QUARANTINE NOTICE

Reference number:	QN-18-0045	Issued: 22 July 2016
Subject:	Boot Fuse Box Fuse Replacement	
Model(s):	Rapide, Rapide S, Taraf 16MY	
VIN Range:	Refer to the separately published Vehicle Identification Number (VIN) list	
Applicable to:	All Dealers	
Distribute to:	After Sales Manager Service Manager Sales Manager	Warranty Technician(s) Parts

Figure 1

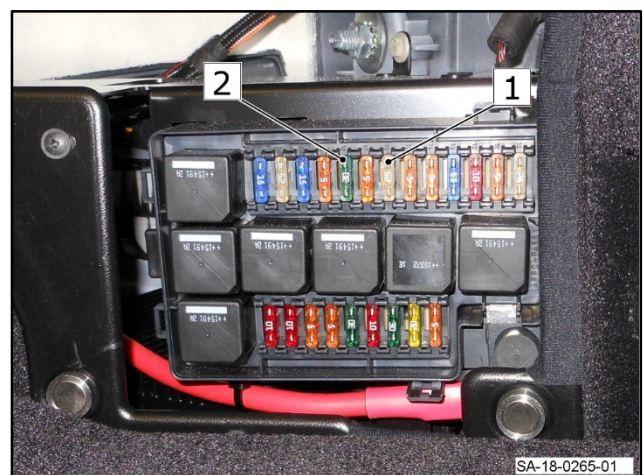
A quantity of Rapide, Rapide S and Lagonda Taraf vehicles have been released from the factory with fuses of an incorrect rating installed at two locations in the boot fuse box. Please refer to the separately published list of VINs and do the Workshop Procedure that follows to all of the vehicles in the list to replace the fuses with items of the correct rating.

1. Open the boot lid.
2. Remove the right rear carpet from the side of the boot (refer to Workshop Manual procedure 01.05.FP).
3. Use a fuse removal tool to remove the 25A fuse from fuse location number 16 (item 1, Figure 1). Replace the fuse with a fuse of 5A rating.

4. Use a fuse removal tool to remove the 30A fuse from fuse location number 18 (item 2, Figure 1). Replace the fuse with a fuse of 5A rating.
5. Install the right rear carpet.
